To: All Service Providers
From: M. Angela Foraker, Executive Director
Strategy, Sourcing, & Support
Date: November 4, 2022
Re: Addendum #1 for ITB 21368 – MetroHealth Clinic Upgrades at Clara Westropp, Mound, and Glenville

This Addendum #1 reflects the following:

New MetroHealth
ODH
SBHC
Health Care Expansion Program

2 FURNITURE & EQUIPMENT PLAN
 SCALE: 1/4" = 1'-0"

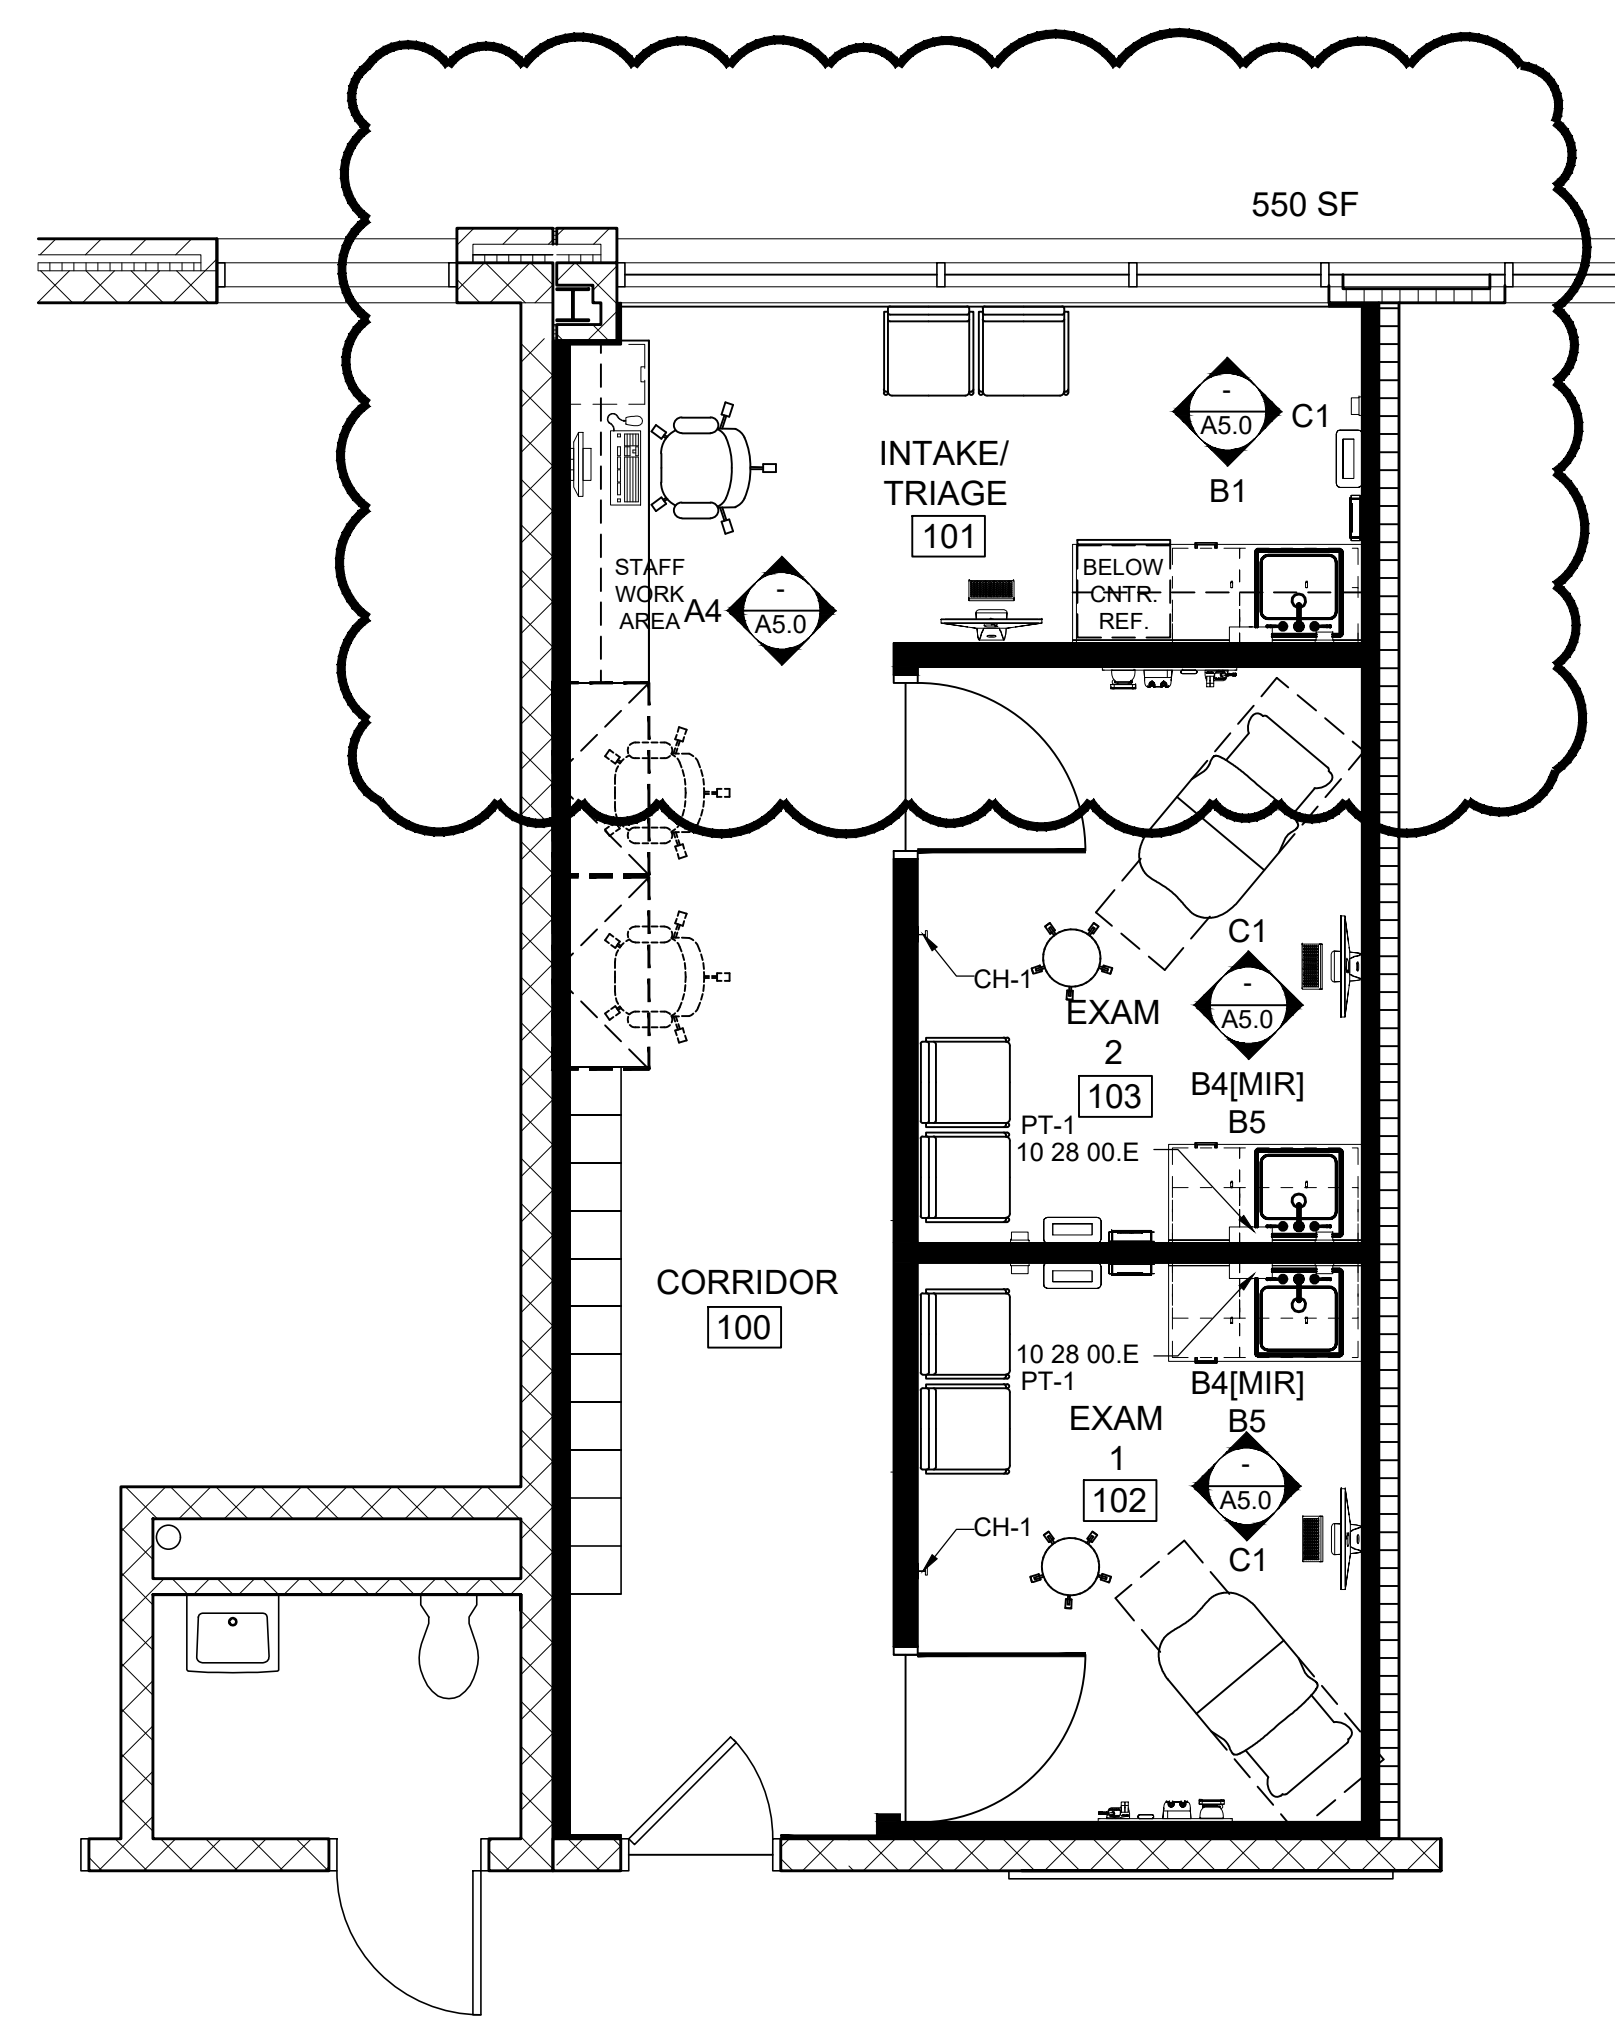
14. The layout for Intake Triage (2/A4.0) and the elevations (C1 & A4/A5.0) do not match. What are the casework requirements for this room(Mound)?

See Sheets A4.0 and A5.0 for Revisions

2 FURNITURE & EQUIPMENT PLAN

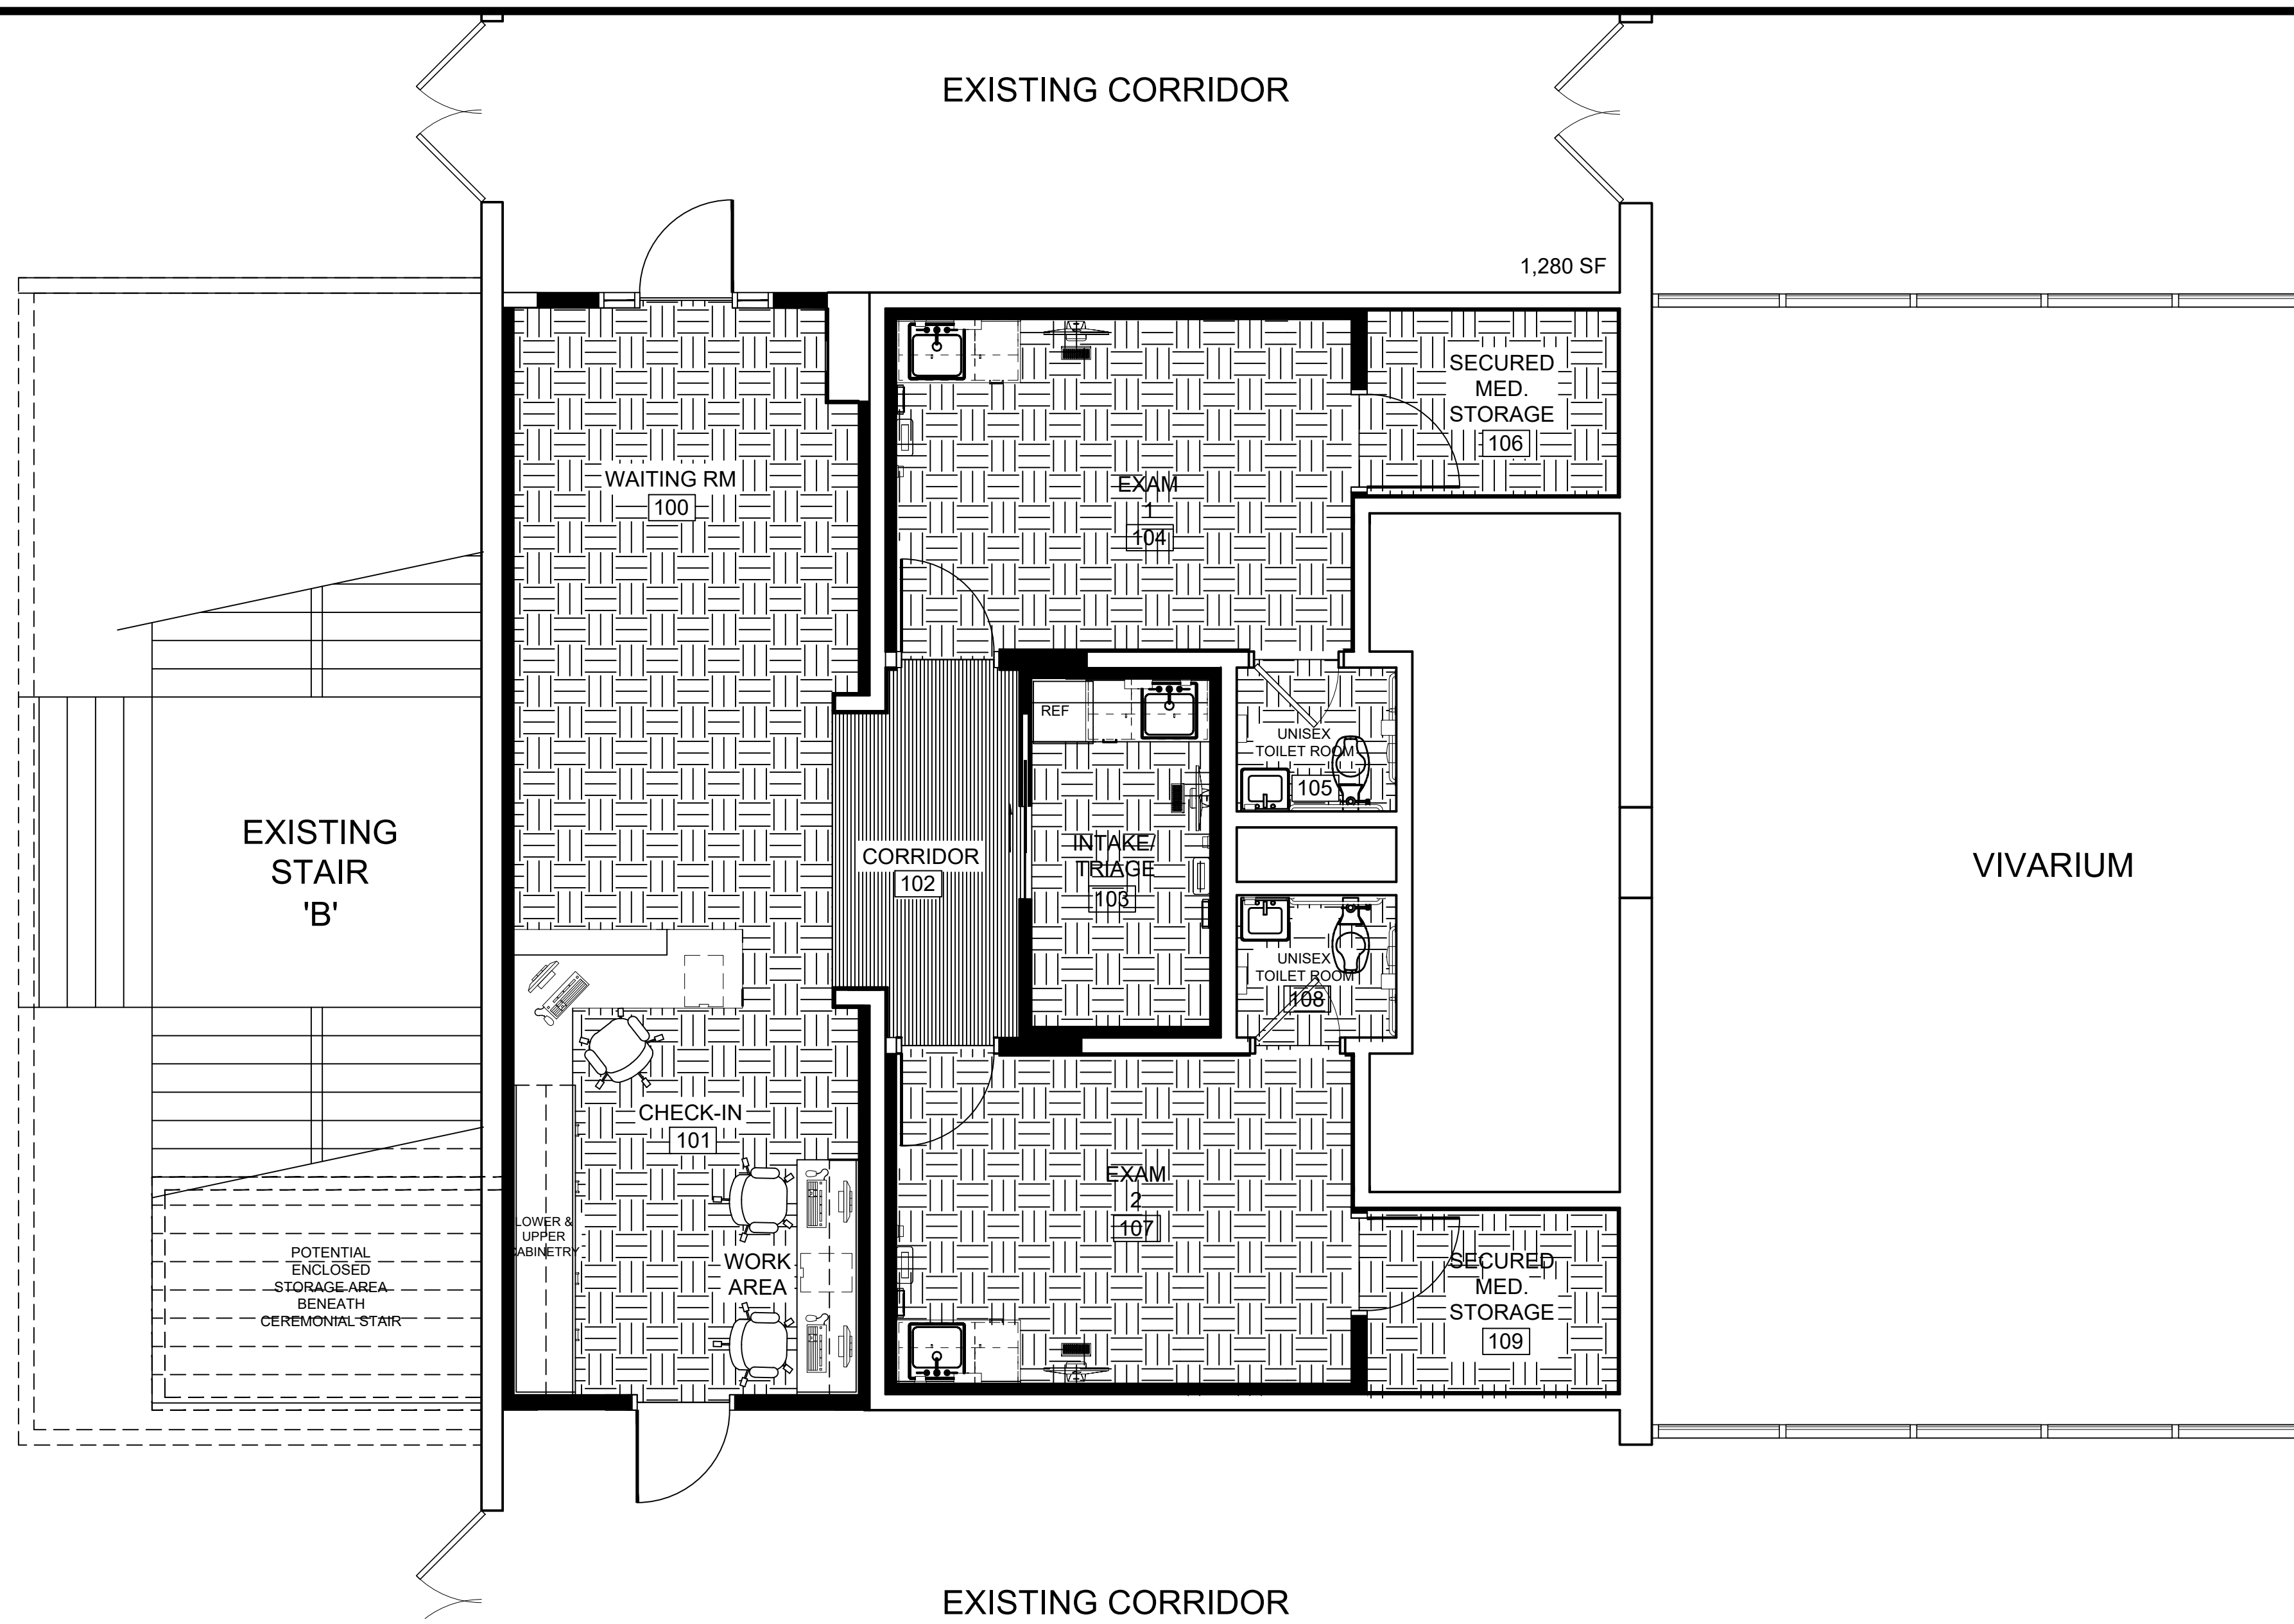
10. On the equipment/furniture plan (A4.0), elevation marker A4/A5.0 is used at the Check In Work Area. That elevation is labeled Staff Break Room and the layout/elevation do not match. What are the casework requirements for this room(Clara Westropp)?

11. Where is elevation B1/A5.0 used(Clara Westropp)?

12. Elevation A3 for Triage/Intake does not match the floor plan layout. What are the casework requirements for this room(Clara Westropp)?

13. Elevation A1/A5.0 does not match the floor plan. The floor plan shows 4 base and 4 wall cabinets, the elevation shows 2 base and 1 wall cabinet. Which is correct(Clara Westropp)?

See Sheets A4.0 and A5.0 for Revisions

See Sheets A4.0 and A5.0 for Revisions

See Sheets A4.0 and A5.0 for Revisions

See Sheets A4.0 and A5.0 for Revisions
